# UNITED STATES PATENT AND TRADEMARK OFFICE

10/561,532

<b>Office Action Summary</b>	<b>Application No.</b> 10/561,532	<b>Applicant(s)</b> DEKKER ET AL.	
	<b>Examiner</b> Michael B. Shingleton	<b>Art Unit</b> 2815

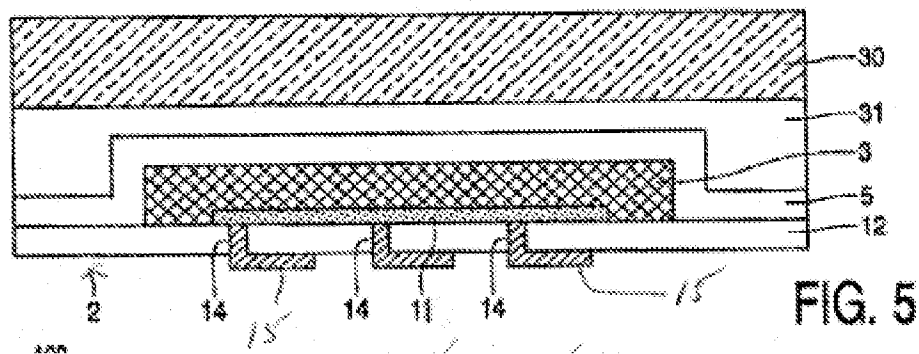
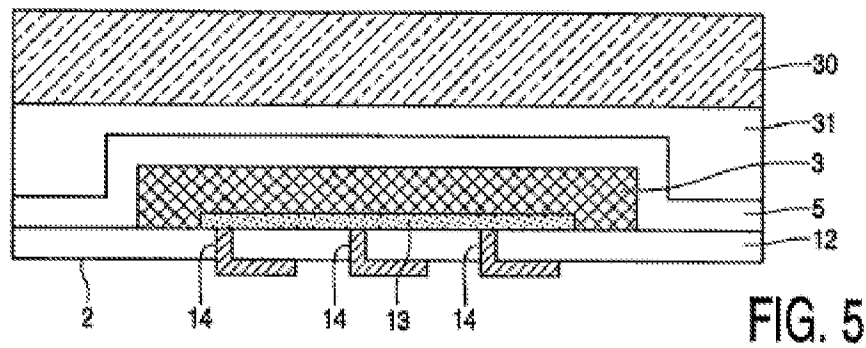
Claims 1, 3-7, 9 and 11 are rejected under 35 U.S.C. 112, first paragraph, as failing to comply with the written description requirement. The claim(s) contains subject matter which was not described in the specification in such a way as to reasonably convey to one skilled in the relevant art that the inventor(s), at the time the application was filed, had possession of the claimed invention. Newly proposed drawings and the specification contain new matter that is required to be cancelled in response to this office action. Specifically, one issue of new matter rests in the functional layer now indicated as 15 in the newly submitted drawings. There is absolutely no support for this in the original disclosure. In fact the original disclosure as well as the newly presented drawings clearly prove beyond any doubt that this "15" cannot be the functional layer. Here's why; in the marked up copy of the specification it states:

The originally Figures and the newly proposed figures clearly show what applicant now refers to as "functional layer 15" as being composed of exactly the same material as that in the apertures 14 which as noted above can only be metal (Note the cross hatching.). That's the original disclosure.

Thus there is absolutely no question that what applicant now points to as element 15 can only be that of metal which makes the newly added subject matter reciting that the functional layer is by example includes electro-optical layers, etc. is clearly new matter never before presented. Note the new matter below of element 15 :

FIG. 5

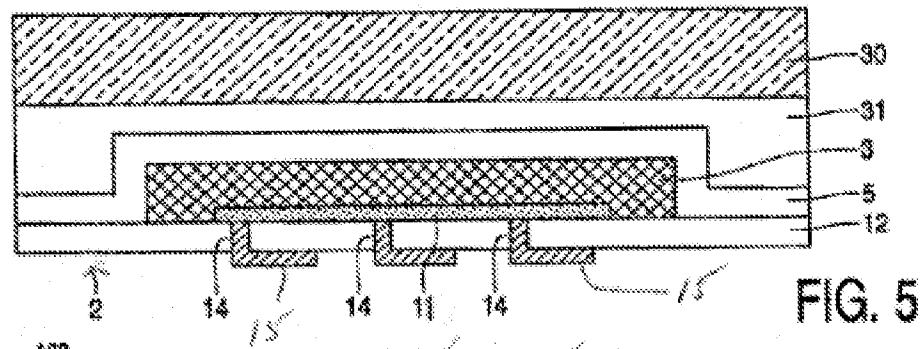
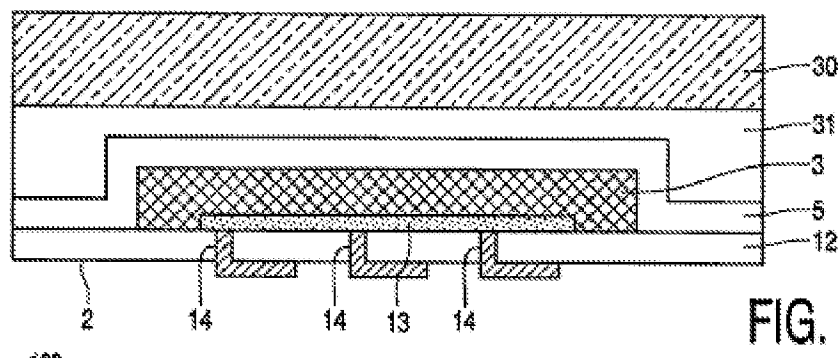
The previous amendment believed to be filed in February of '09 is objected to under 35 U.S.C. 132(a) because it introduces new matter into the disclosure. 35 U.S.C. 132(a) states that no amendment shall introduce new matter into the disclosure of the invention. The added material which is not supported by the original disclosure is as follows: Newly proposed drawings and the specification contain new matter that is required to be cancelled in response to this office action. Specifically, one issue of new matter rests in the functional layer now indicated as 15 in the newly submitted drawings. There is absolutely no support for this in the original disclosure. In fact the original disclosure as well as the newly presented drawings clearly prove that this cannot be the functional layer. Here's why. In the marked up copy of the specification it states:

The originally Figures and the newly proposed figures clearly show what applicant now refers to as "functional layer 15" as being composed of exactly the same material as that in the apertures 14 which as noted above can only be metal (Note the cross hatching.). That's the original disclosure.

Thus there is absolutely no question that what applicant now points to as element 15 can only be that of metal which makes the newly added subject matter reciting that the functional layer is by example includes electro-optical layers, etc. is clearly new matter never before presented. Note the new matter below of element 15 :

Applicant is required to cancel the new matter in the reply to this Office Action.

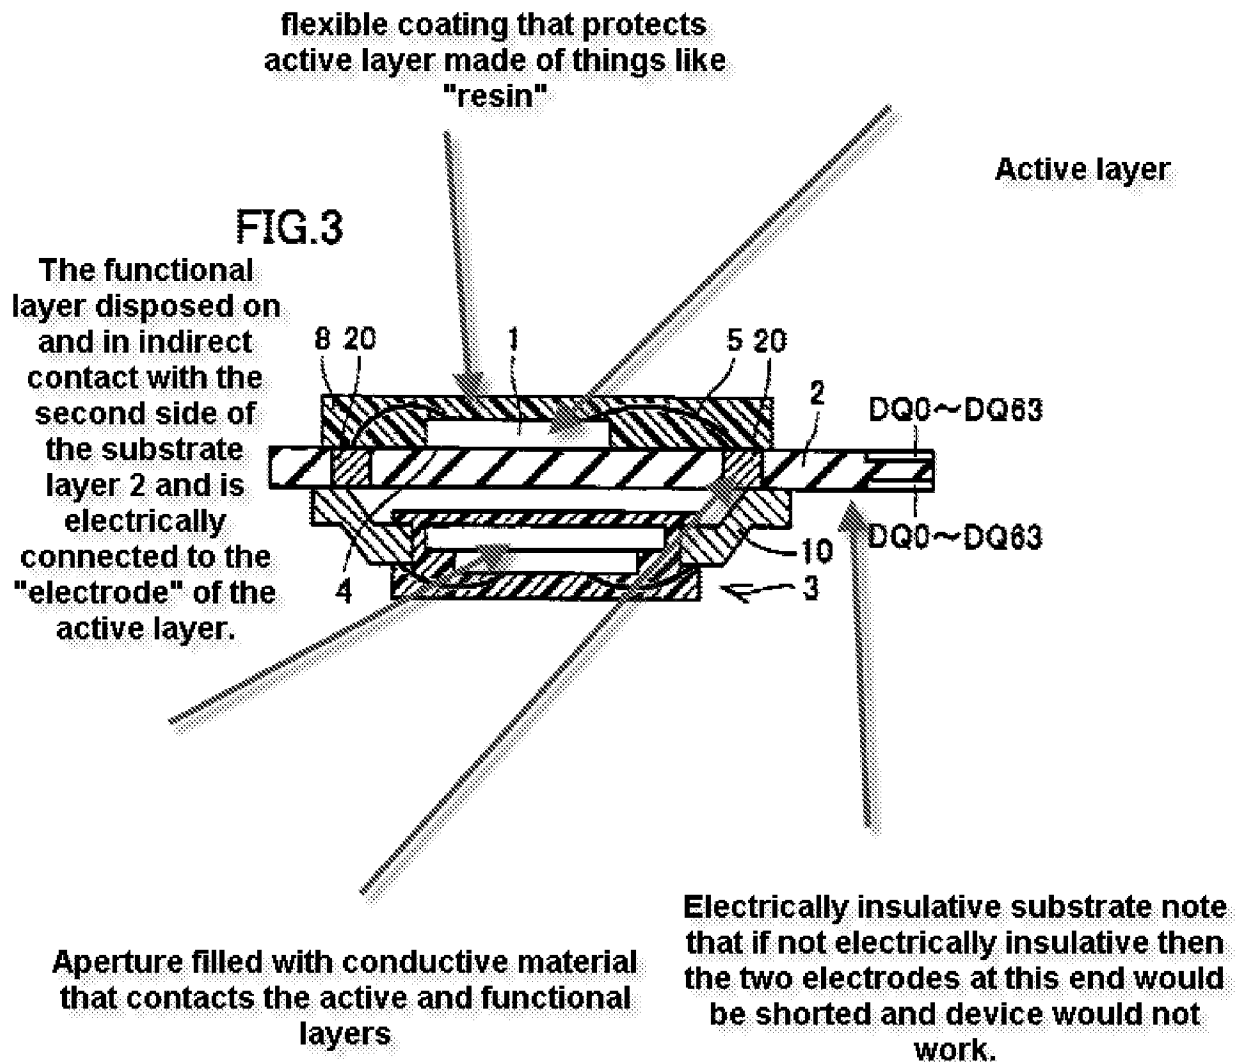
Claim 1 is so so extremely broad. First of all applicant still has not provided a proper drawing to an invention where the functional layer is on the "second side of the substrate". What applicant now points to as element 15 is composed of the same exact material as that of 14 with is pure conductor as presented by the original disclosure. This just cannot be the functional layer, period. Again what was shown in the original disclosure was that of pure conductor and thus there continues to be clear new matter that must be cancelled in response to this office action. However, as stated above claim 1 is so so so extremely broad. In essence claim 1 has a circuit on one side and a circuit on the other side of a substrate with a through hole connecting the two circuits. The only other thing added besides just stated is that there is a "flexible coating" formed on the "first side" of the substrate acting as a protective cover. Applicant should be well aware of the numerous flexible circuit boards that exist with through holes where the active or functional elements(layers) are mounted on both sides of the flexible circuit board and connected to each other via the through holes. More "rigid" versions like motherboards common in computers also are commonly known to exist with active and functional layers but all versions are flexible to some degree and applicant just has not claimed nor is there any support in the original disclosure to the degree, i.e. just how flexible is flexible as meant by applicant. The examiner wants to help applicant as much as possible to get to allowable subject matter and because there is no support for the degree of flexibility the examiner cannot suggest a limitation as to the degree as this would introduce new matter into the specification that has already been plagued with numerous errors. Matsumoto has been provided to show that the invention as set forth in claim 1, notwithstanding the new matter that exists in the present application, is anticipated by the prior art. The following reproduced drawing should make it clear that claim 1 is clearly anticipated but a few points are discussed as well to further emphasis this point. Applicant says that the active layer includes "at least one switching element". Well many things can be consider a "switching element" and as Matsumoto intends to use memory chips as the active layer the memory devices contained therein can be called "switching elements" as there state i.e. a 1 of a 0 is switchable. Resin is clearly flexible and is listed as one of the "flexible materials" by applicant. The term "monolithic" is likewise very broad. Clearly even applicant's invention is not "formed from a single crystal". Applicant's invention it is like that of Matsumoto "consisting of or constituting a single unit" i.e. monolithic. Should applicant like to
